Re: Revised Submission #3 – Kittery Car Wash
Tax Map 28 Lot 25D, Route 236
Job No. 19-134

SUPPLEMENTAL NARRATIVE (9/3/2020)

**RE: Town of Kittery, Planning Board Services
Site Plan Review No 2
Kittery Car Wash (Route 236) Tax Map 28, Lot 25D
CMA #591.131**

EXHIBIT 1: WETLAND VS. DRAINAGE DITCH

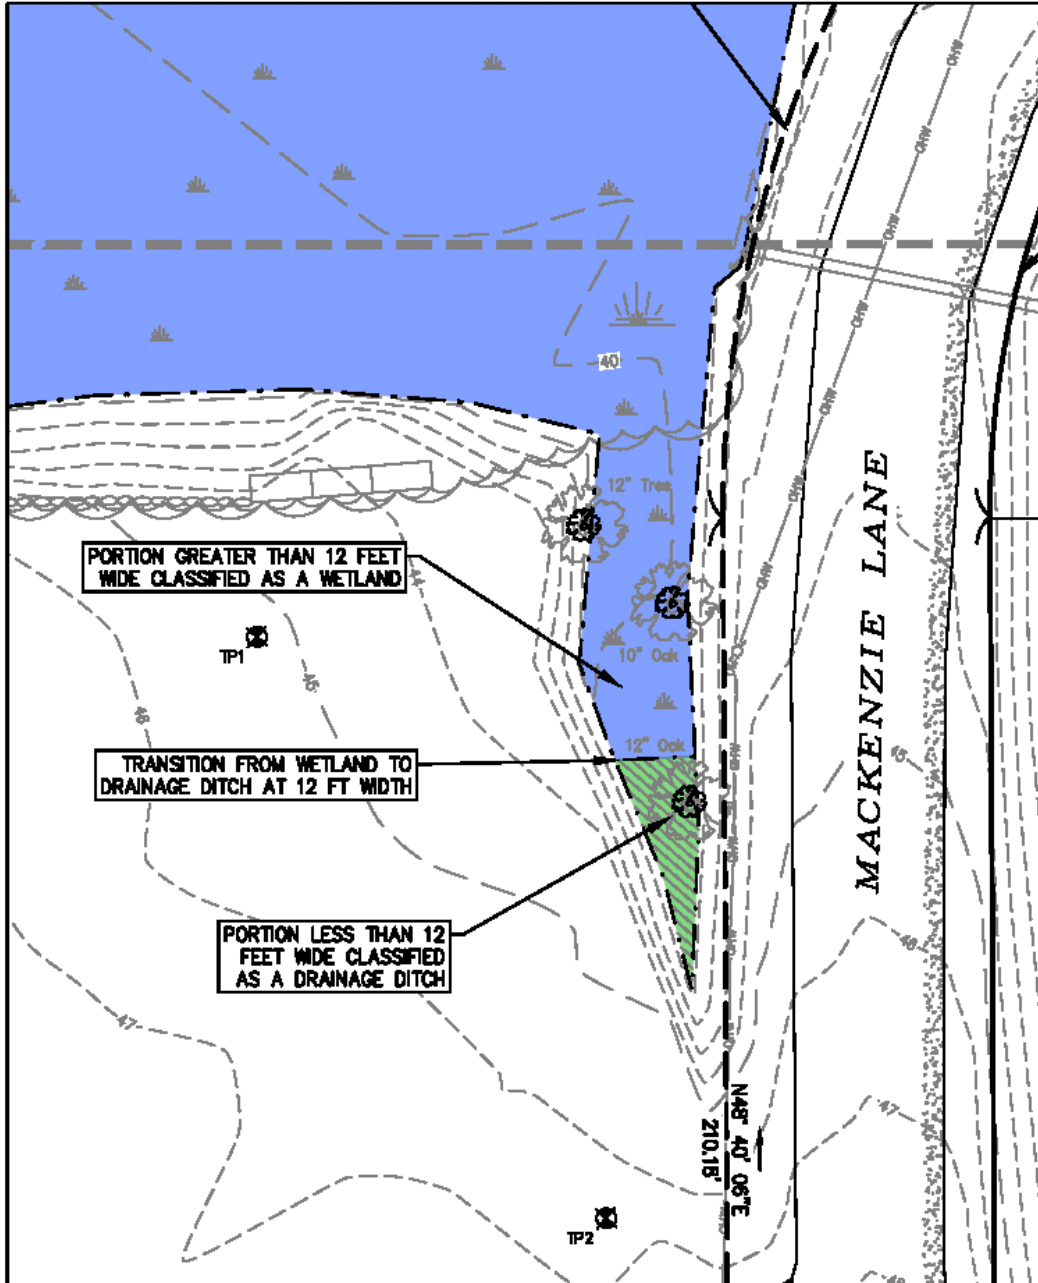
The wetland delineation by Mr. Noel is depicted on the provided site plans. On Sheet C3, the location where the swale is twelve (12) feet in width is labeled on the plan and the portion of the swale that is less than twelve (12) feet in width is identified as the cross hatched area (see also Exhibit 1 attached hereto). The proposed entrance to the site from MacKenzie Lane crosses over this hatched area. The building setback to the car wash building is measured from the transition line between the portion classified as a wetland and the portion classified as a drainage ditch.

As Mr. Noel states in his letter, the hatched area is "a regularly maintained roadside ditch/swale along MacKenzie Lane that drains surface water into the rest of the delineated wetland." It should be noted that the runoff from MacKenzie Lane and Route 236 that currently flows untreated directly to the wetland via this drainage swale is proposed to be intercepted by a

culvert and routed to a stormwater treatment basin. By doing so, the runoff will now receive treatment and prevent road debris and sediment from washing into the wetland.

SHEET: PROPOSED SITE & UTILITY PLAN

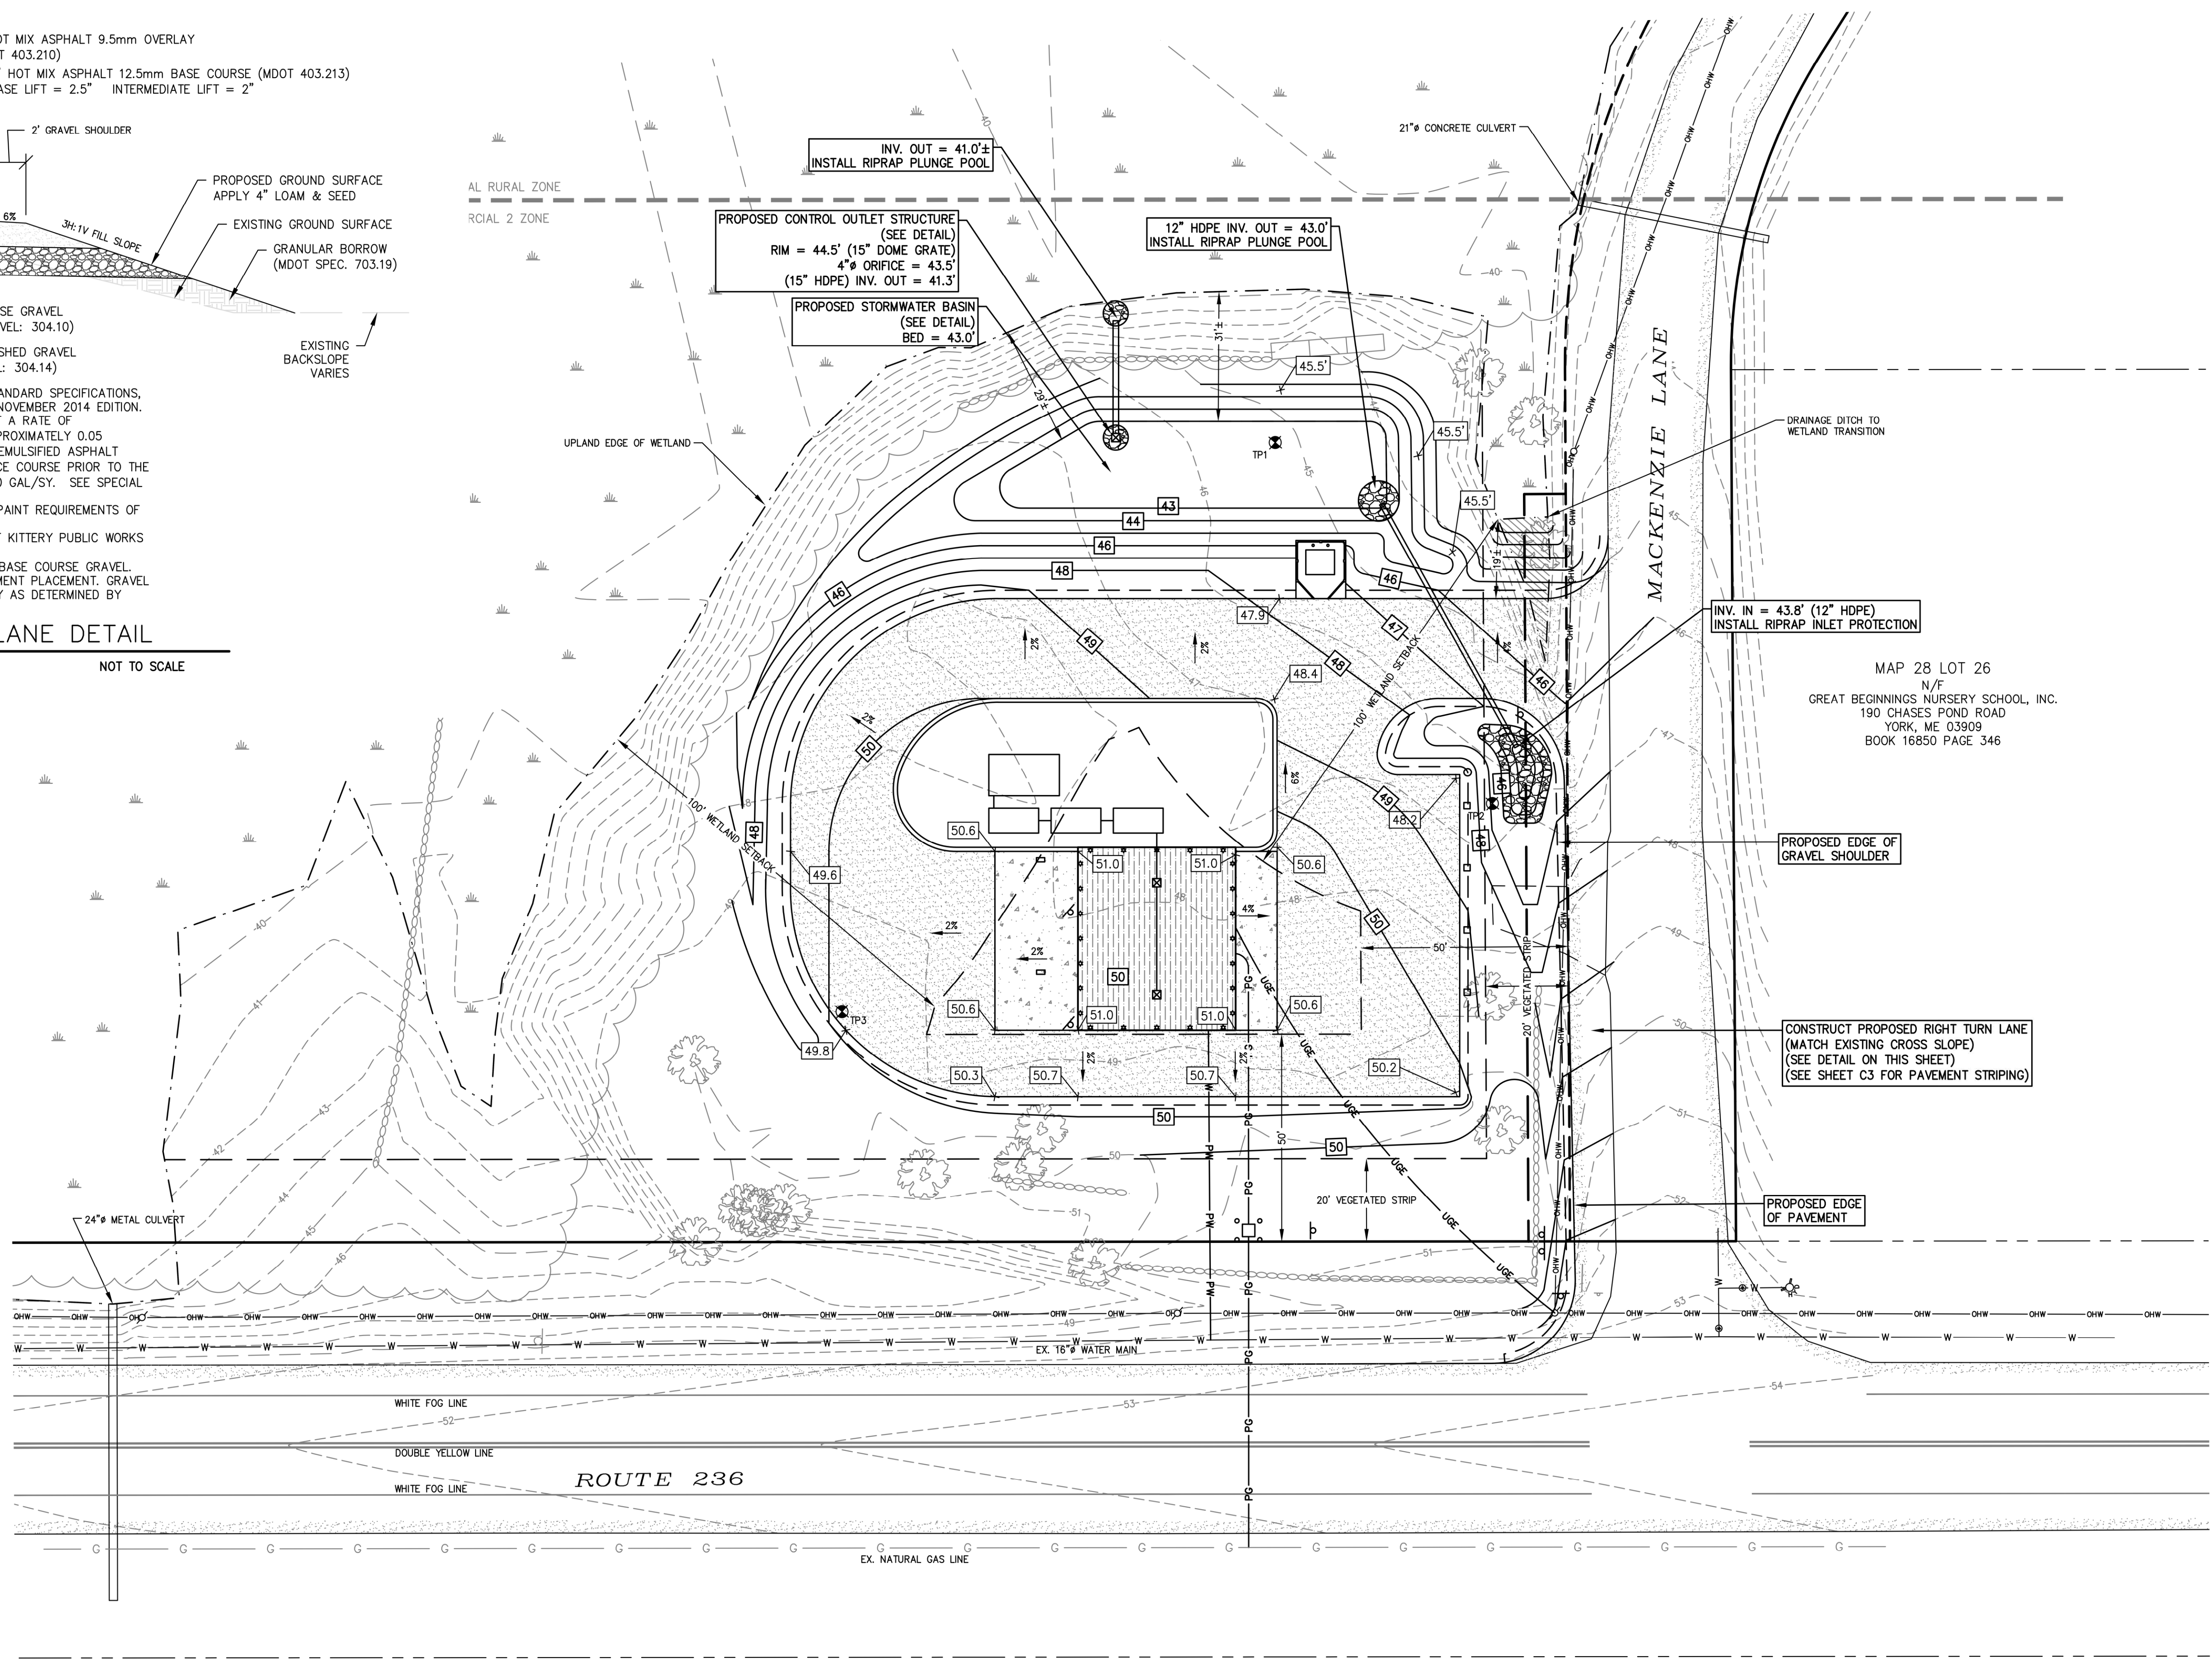
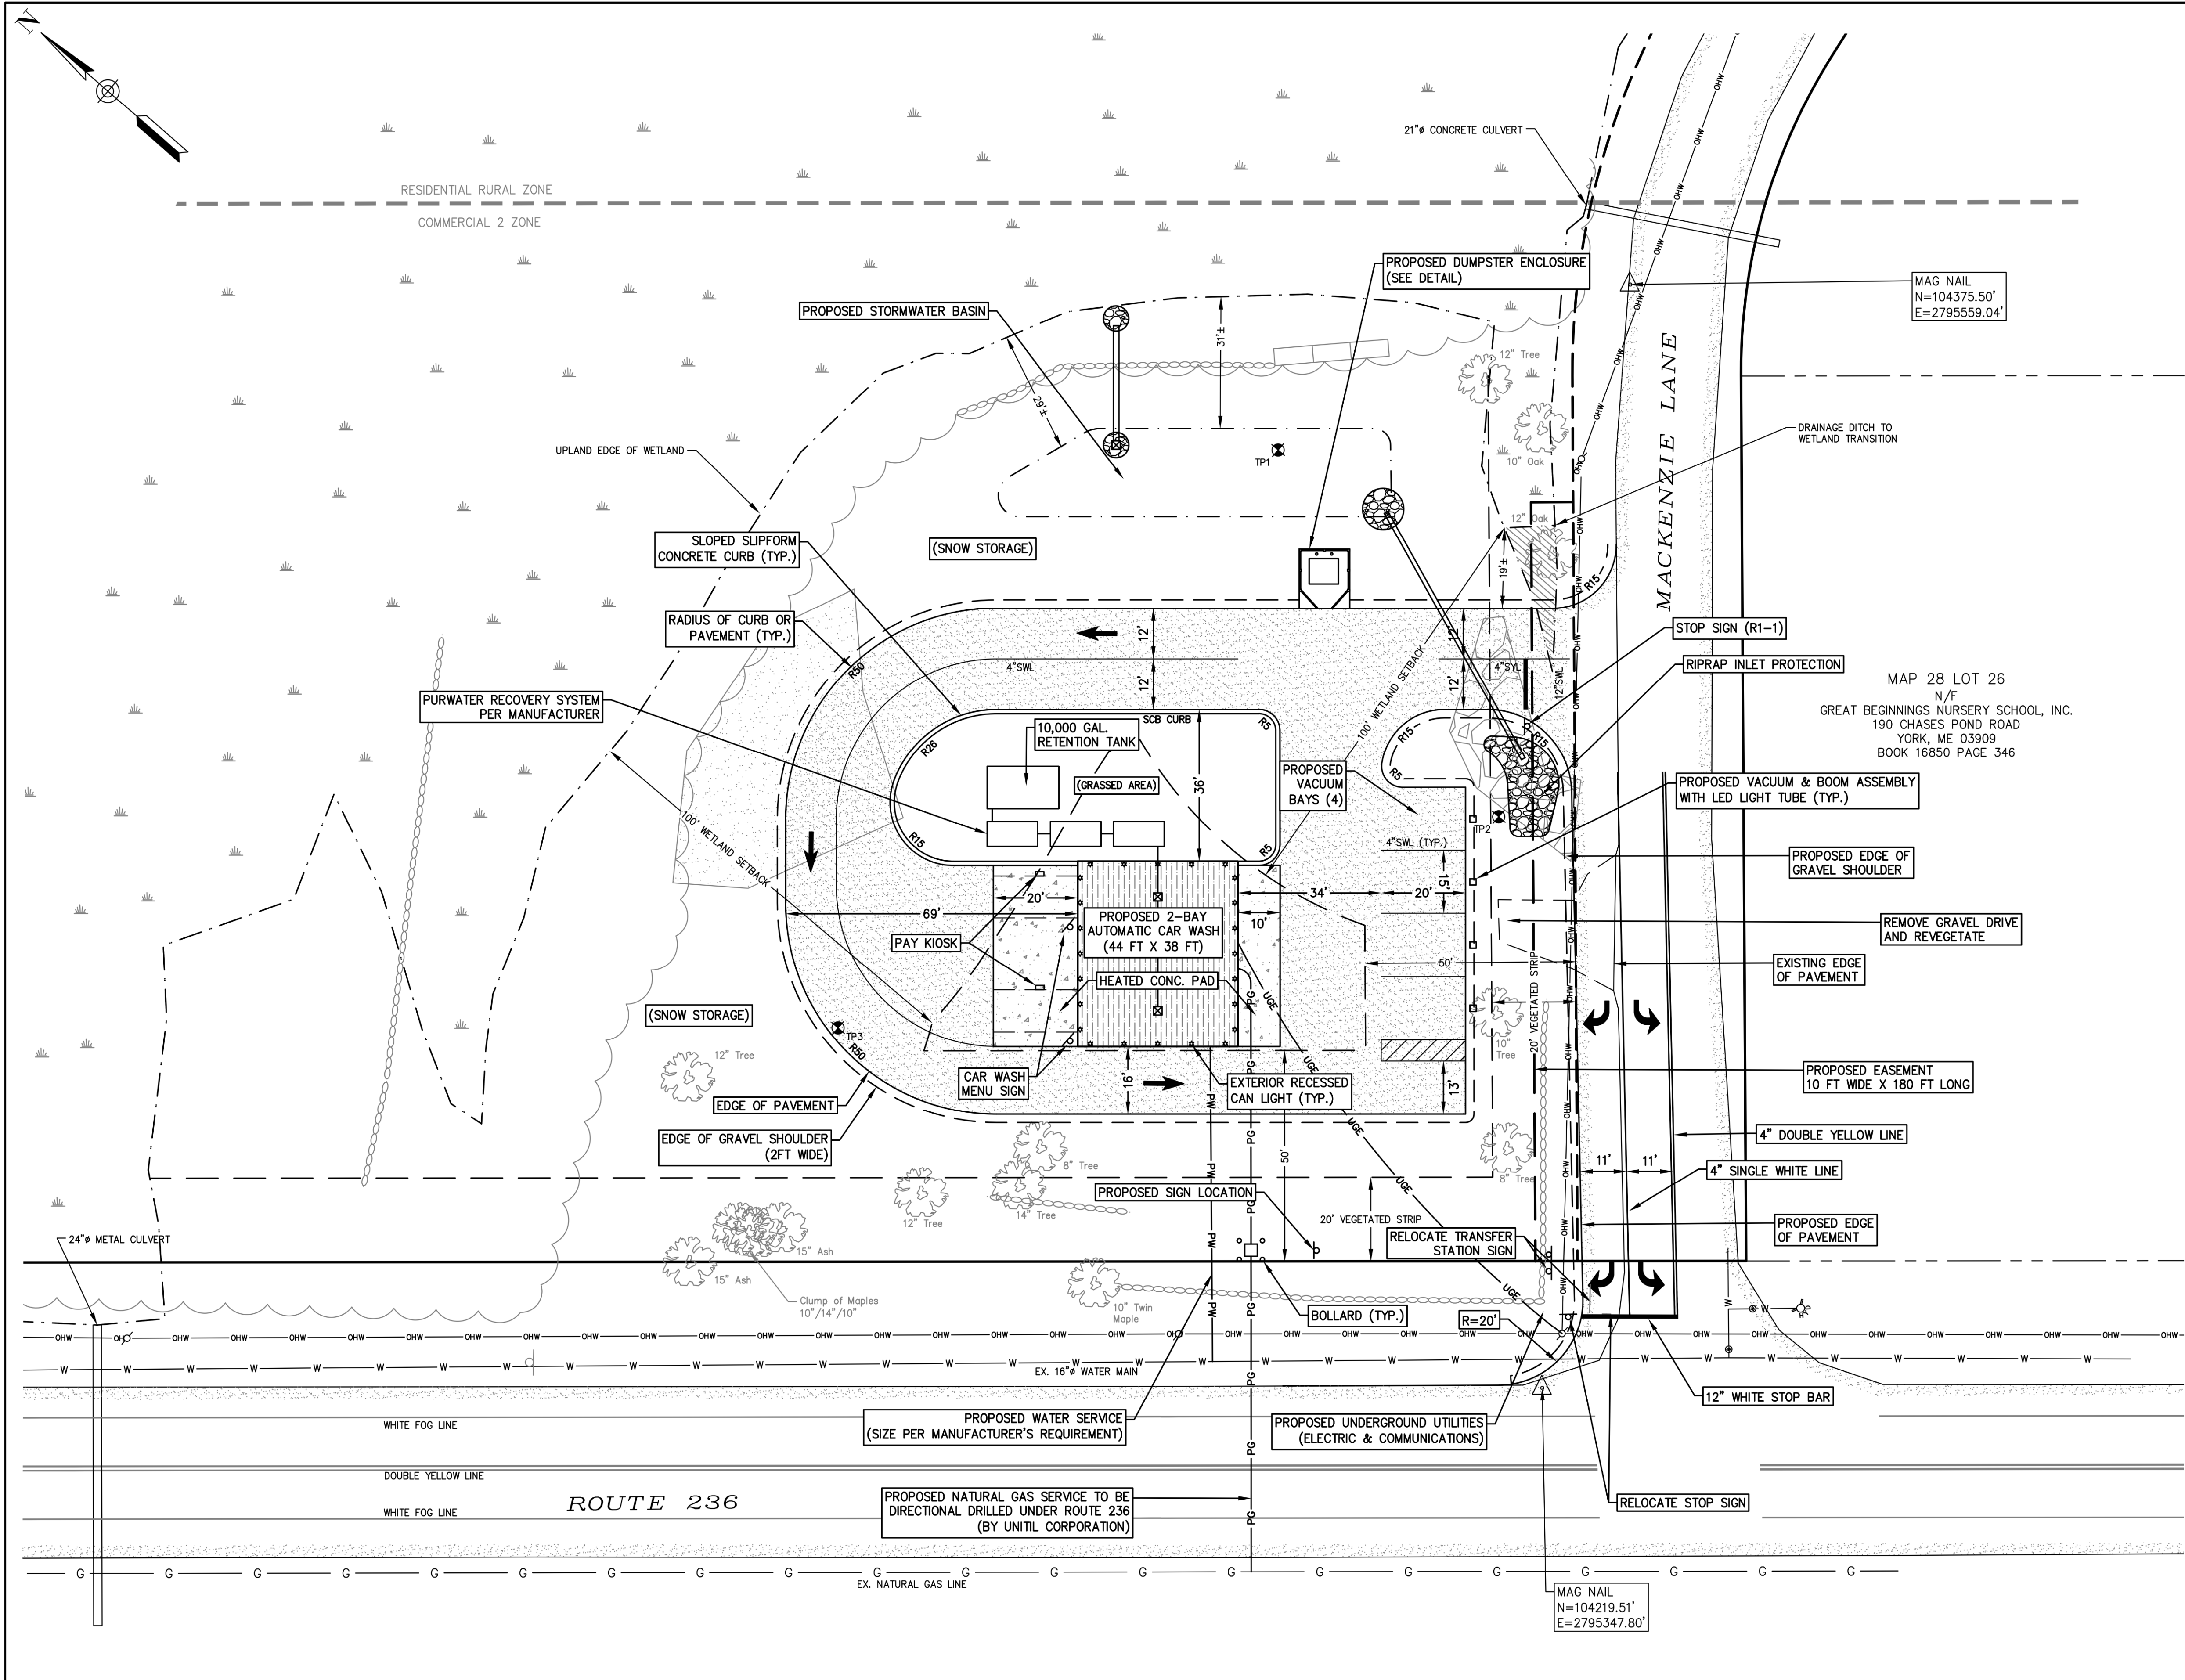
- f. **Plan Notes:** We have added Note 14 "Special requirements pertaining to excavation of existing fill materials" to Sheet C3 that summarizes the requirements stated above.

13. SEE LIGHTING PHOTOMETRIC PLAN AND PRODUCT SHEET BY R.A.B. LIGHTING SUBMITTED TO THE TOWN OF KITTERY AS PART OF THIS SITE PLAN APPLICATION FOR LIGHTING SPECIFICATIONS.
14. SPECIAL REQUIREMENTS PERTAINING TO EXCAVATION OF EXISTING FILL MATERIALS

FREESTANDING SIGN DETAIL
NOT TO SCALE

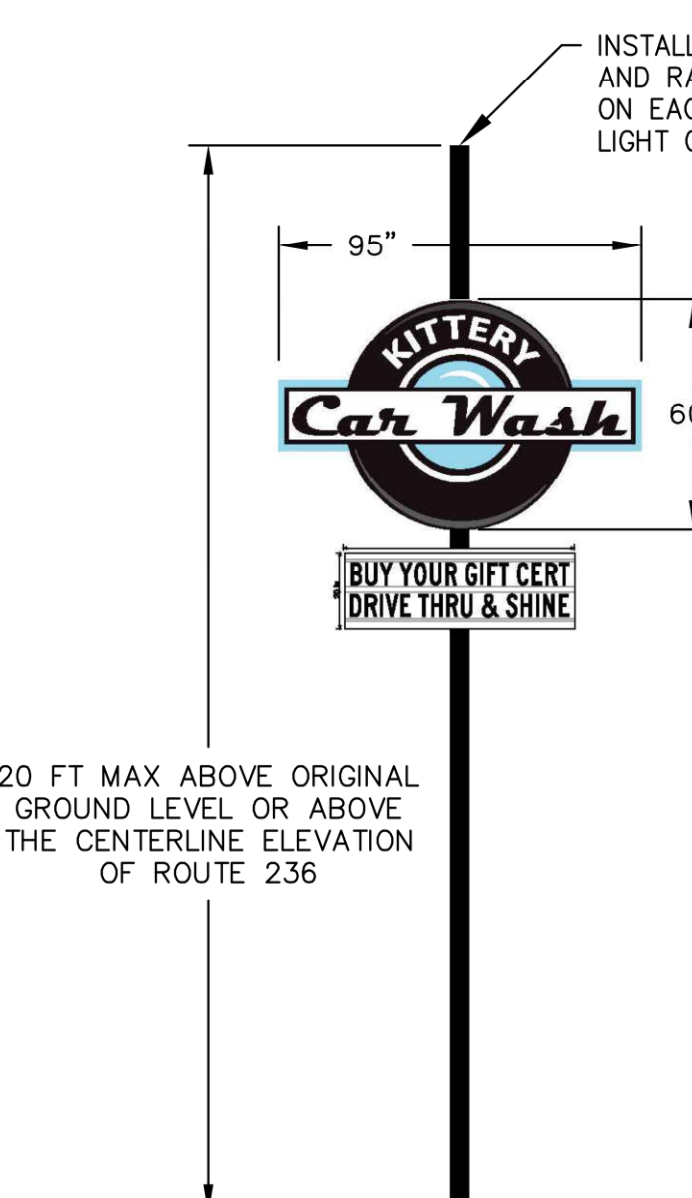
1. Supplemental Narrative
 - a. On-Site Wetland and Drainage Ditch;
 - b. Existing Fill Material;
 - c. On-site Restroom.
2. Updated Site Plan Set – Revision 3 dated September 3, 2020
 - a. Added notes 14 and 15 to Sheet C3;
 - b. Added proposed sign detail on Sheet C6;
 - c. Revised note 4 on Sheet C7.
